Location Address: 2231 FILLMORE ST and 2224 PIERCE ST, HOLLYWOOD FL 33020

Explanation of Request: NEW CONSTRUCTION, 63 UNIT, RENTAL APARTMENT BUILDING

**SUBJECT:** Preliminary Site Plan review for a 63 Unit residential development.

# FILLMORE STREET APARTMENTS

1 SIGNAGE  
N.T.S.

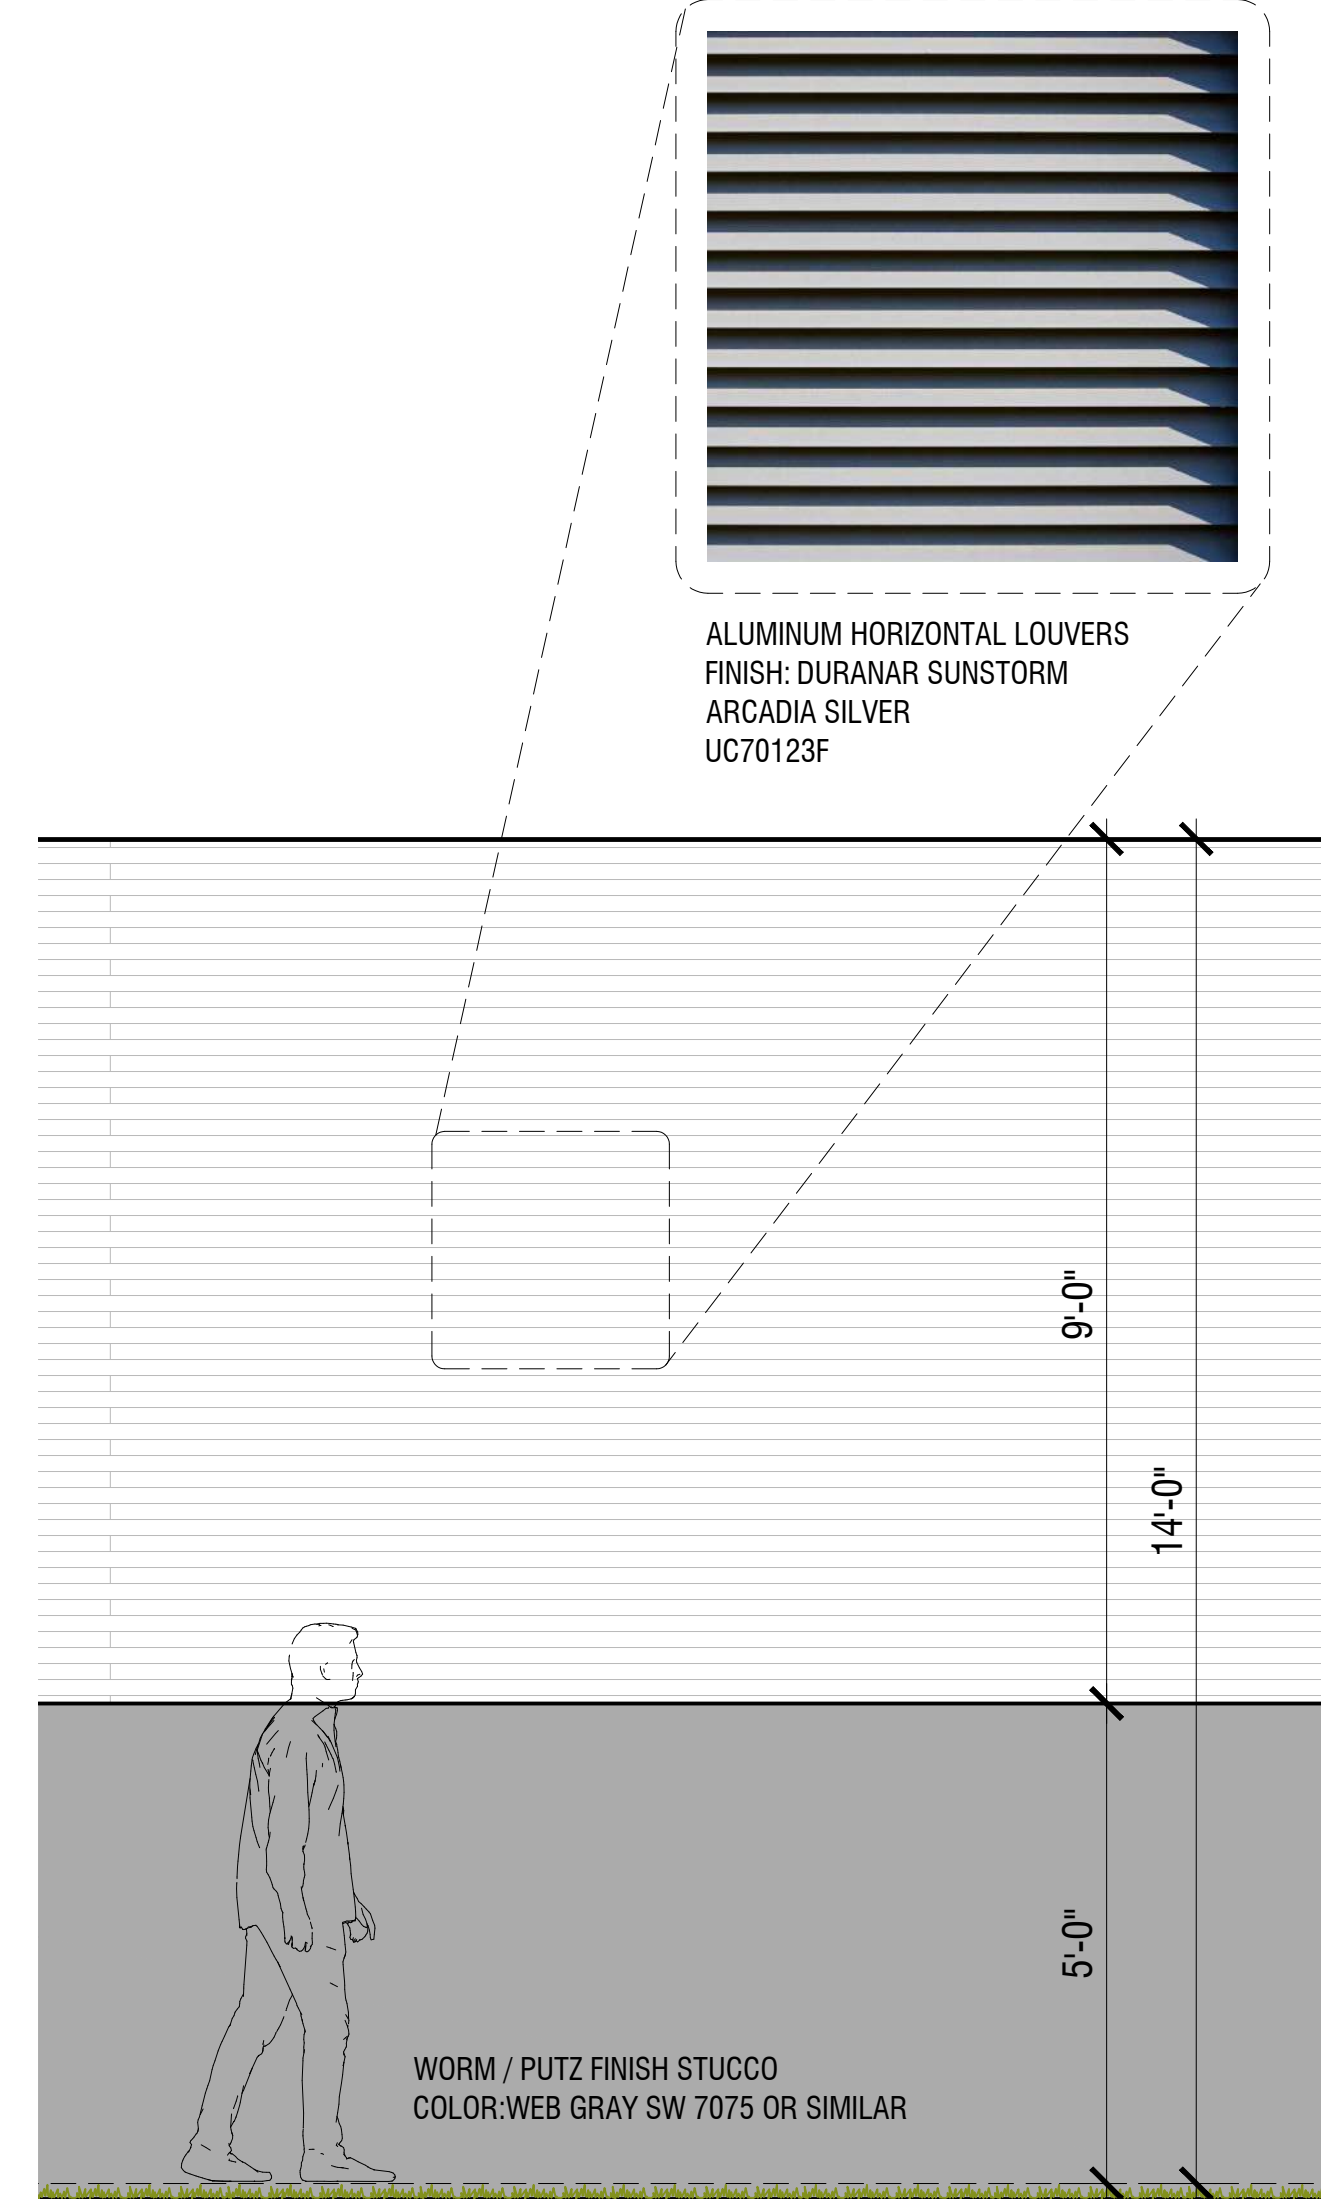
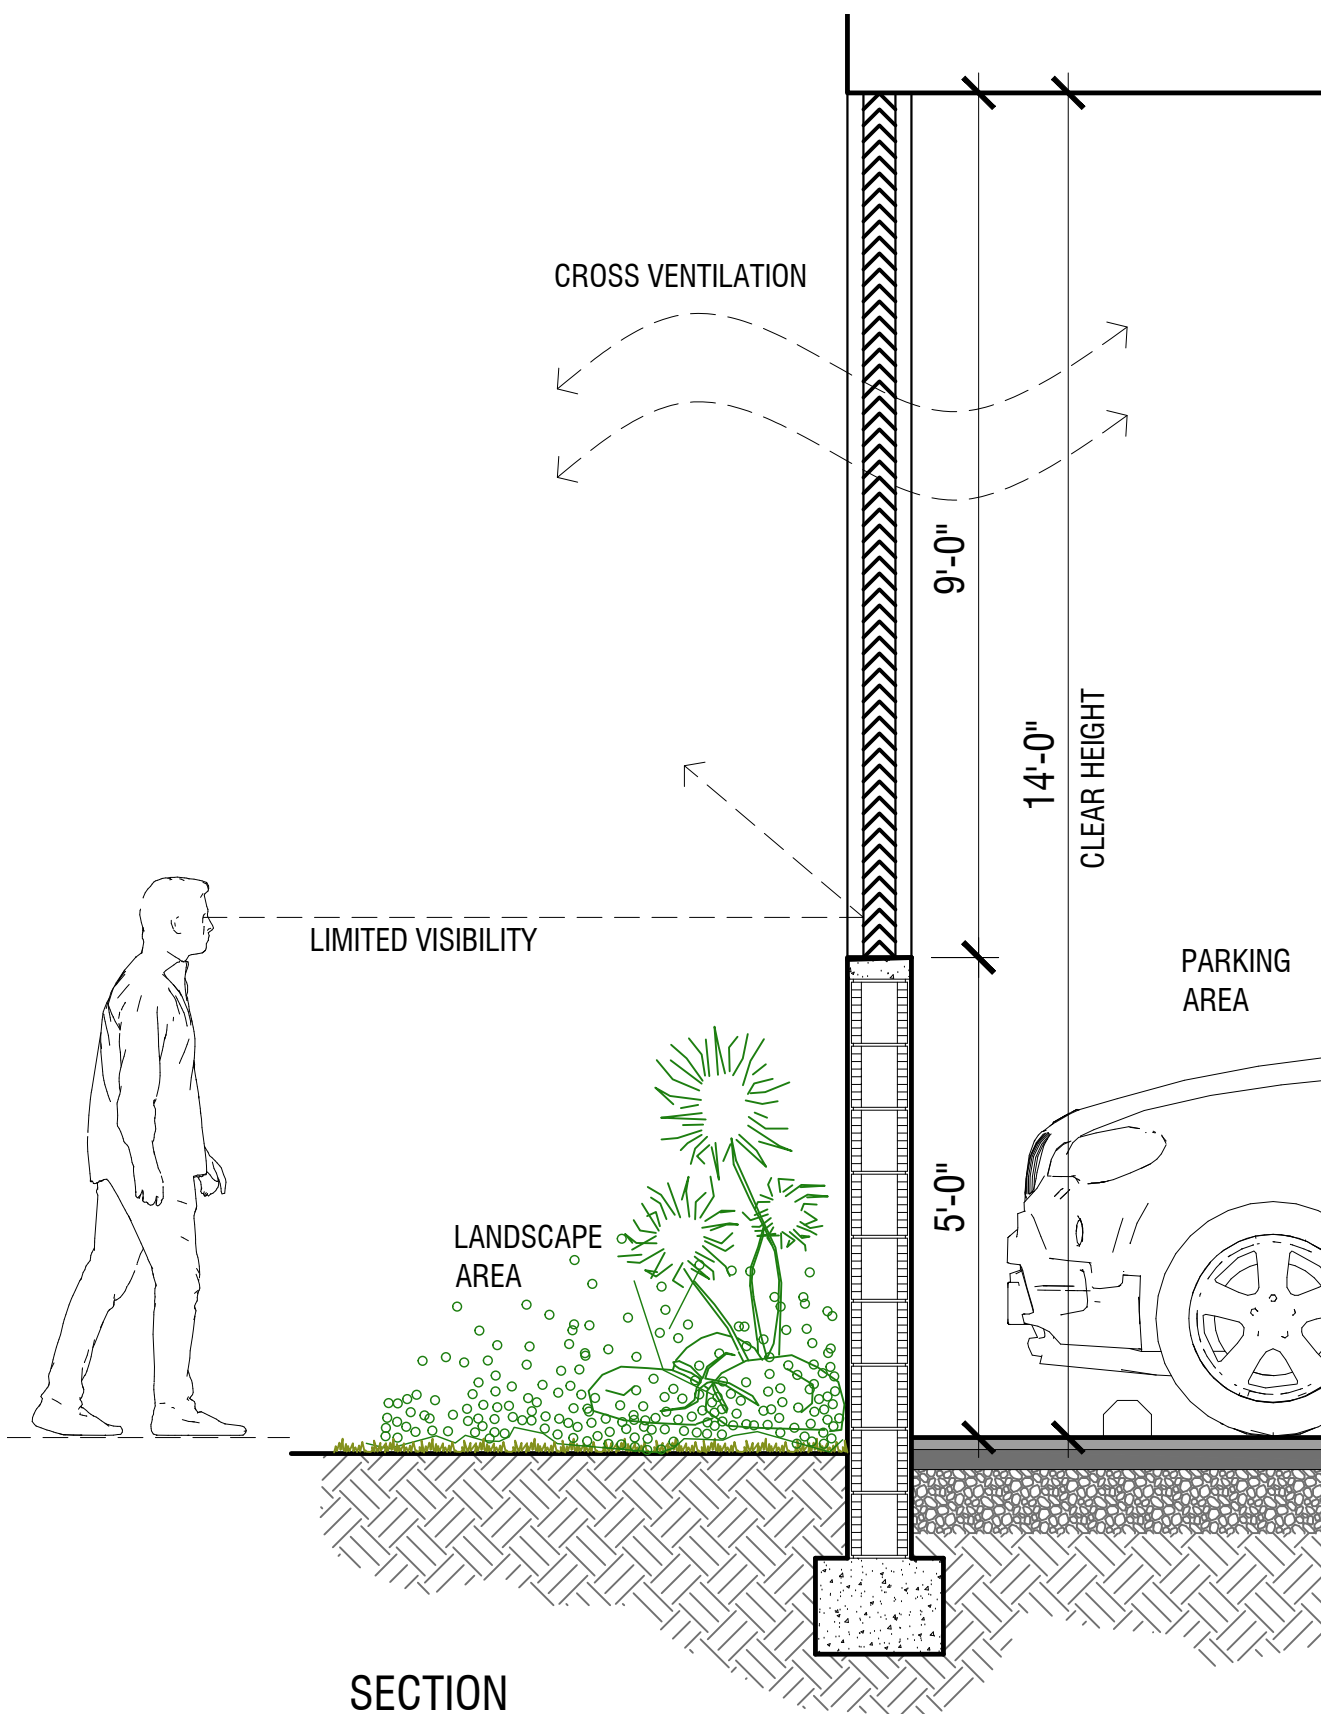
1. For full review, full signage package shall be provided.  
**Please see attached revised Sheets A-1.5 with the requested signage details.**
2. Include note on Site Plan indicating "All signage shall be in compliance with the Zoning and Land Development Regulations".  
**Please see attached revised Sheets A-1.1 with the requested note.**
3. All signs which are electrically illuminated by neon or other means, shall require a separate electrical permit and inspection. Separate permits are required for each sign.  
**Understood.**

2 BIKE RACK  
N.T.S.

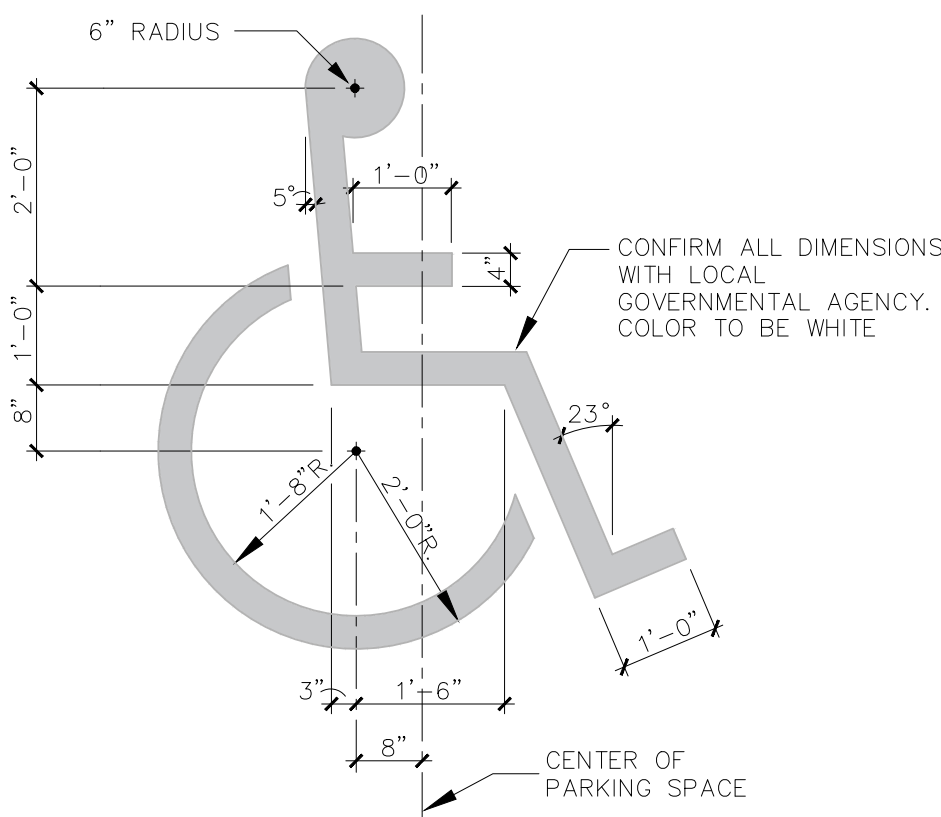
9. Provide a detail for the proposed bike rack.  
**Please see attached revised Site Plan Sheet A-1.5 with the requested detail.**
10. Work with the City's Landscape Architect to ensure that all landscape requirements are met.

# EROSION & SEDIMENT CONTROL PLAN

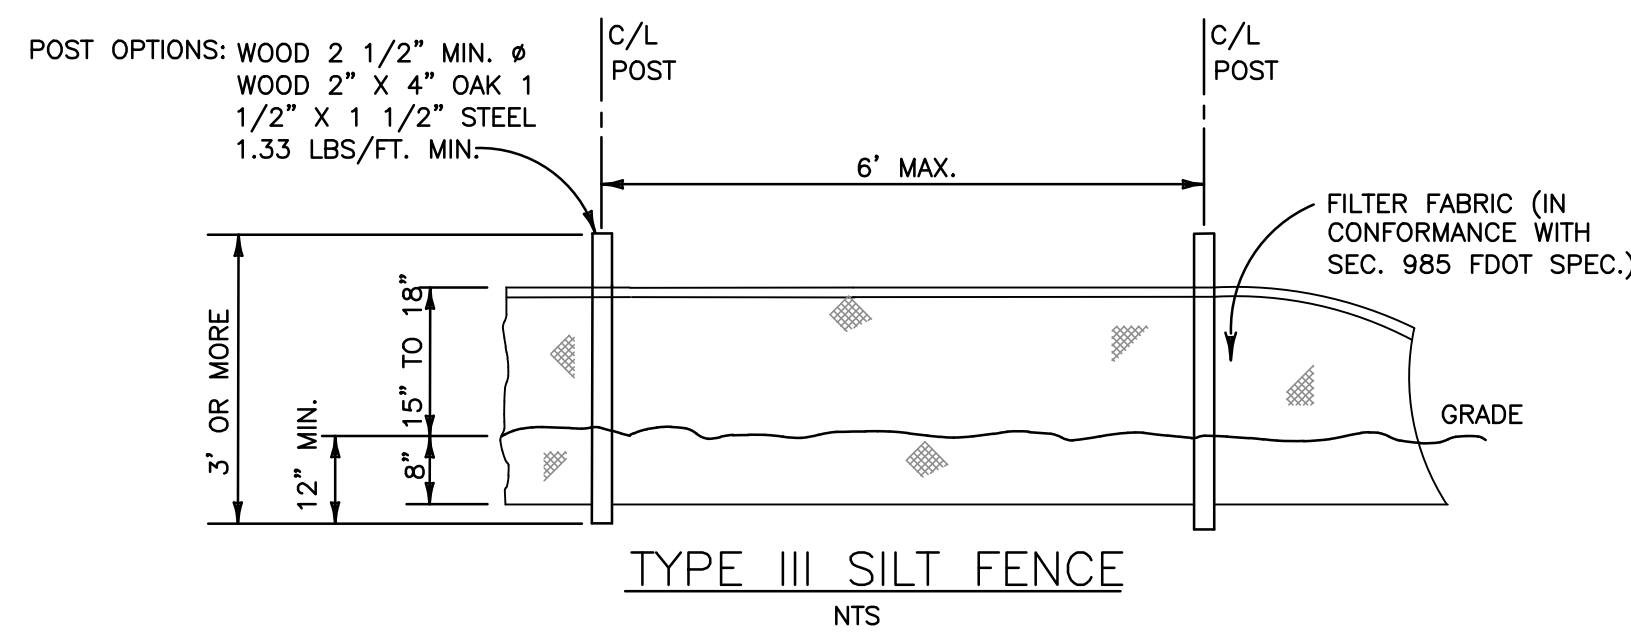
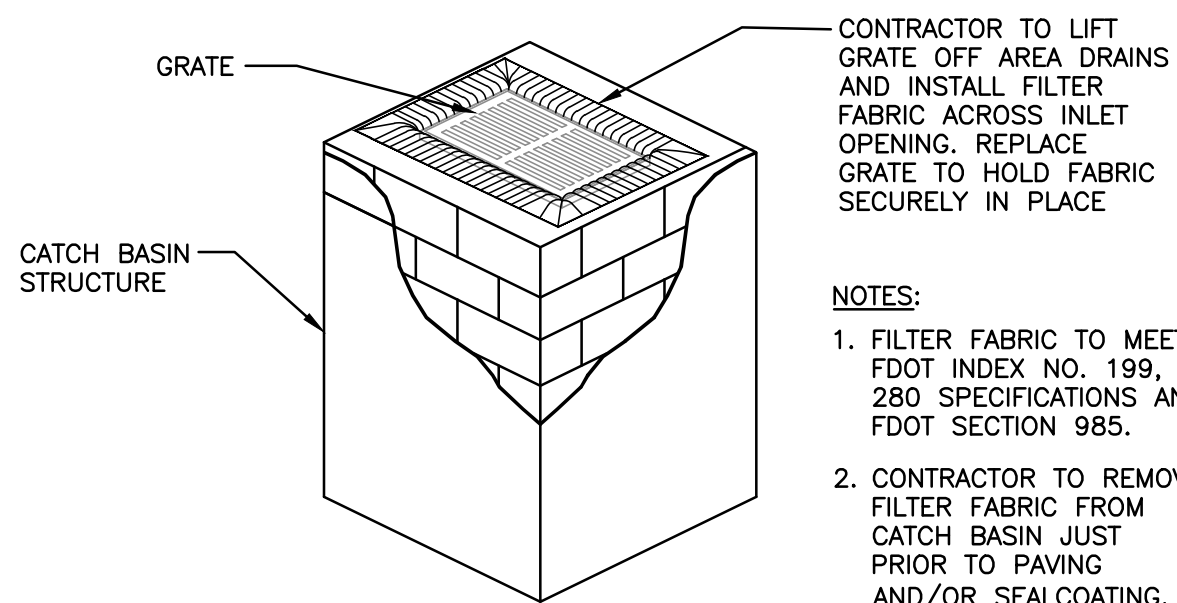
10. Provide preliminary drainage calculations.  
**RESPONSE: Please see attached drainage calculations.**
11. Submit erosion control plan.  
**RESPONSE: Please see sheet C1.**
